# Access Compliance Report

## Public Rights-of-Way

Intersection ID: 9543	Main Street: W_30TH_ST	Cross Street: BELLEFONTE_DR	Location: SW
ADA ID: AC99E6727963	Ramp Type: PerpDiag	Initial Pass/Fail: Fail	Overall Compliance: No
		Severity Score: 17.5

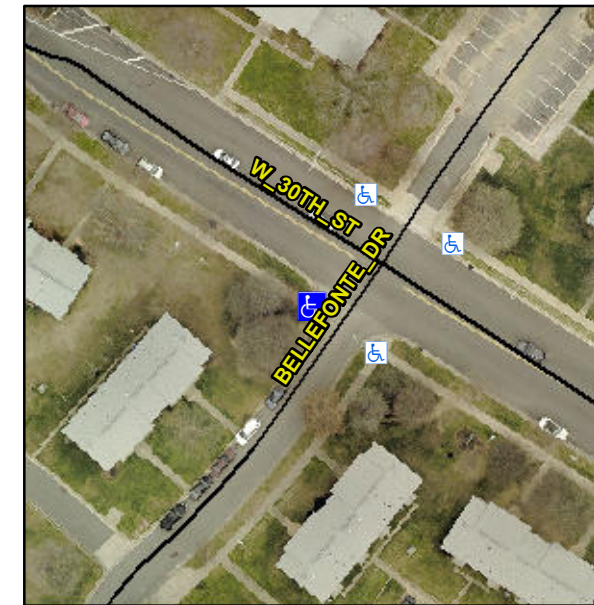
**Not Found, R304.5.1**

Compliance	Description	Data	Compliance	Description	Data
N/A	Ramp Length (in)	58.0	Yes	Ramp Slope (%)	8.3
No	Ramp Width (in)	32.0	Yes	Ramp XSlope (%)	0.3
N/A	Flare Type LT	N/A	N/A	Flare Type RT	N/A
N/A	Flare Slope LT (%)	N/A	N/A	Flare Slope RT (%)	N/A
N/A	Flare Traversable LT?	N/A	N/A	Flare Traversable RT?	N/A
N/A	Landing Length (in)	N/A	N/A	DWS Provided?	N/A
N/A	Landing Width (in)	N/A	N/A	DWS Contrast?	N/A
N/A	Landing Slope (%)	N/A	N/A	DWS Length (in)	N/A
N/A	Landing X Slope (%)	N/A	N/A	DWS Full Width?	N/A
N/A	Landing Curb? (Y/N)	N/A	N/A	DWS Offset (in)	N/A
N/A	Shared Landing?	N/A			
N/A	Gutter Ponding?	Yes	N/A	Gutter Slope (%)	N/A
N/A	Gutter Lip Ht (in)	N/A	N/A	Gutter X Slope (%)	N/A
N/A	Painted X Walk1?	No	N/A	Painted X Walk2?	No
	X Walk 1 Direction	To SE		X Walk 2 Direction	To NE
N/A	X Walk 1 Width (in)	N/A	N/A	X Walk 2 Width (in)	N/A
	X Walk 1 Slope (%)	2.3		X Walk 2 Slope (%)	1.6
	X Walk 1 X Slope (%)	0.9		X Walk 2 X Slope (%)	0.7

**Remove & Replace Curb Ramp With Two New Directional Ramps or Equivalent.**
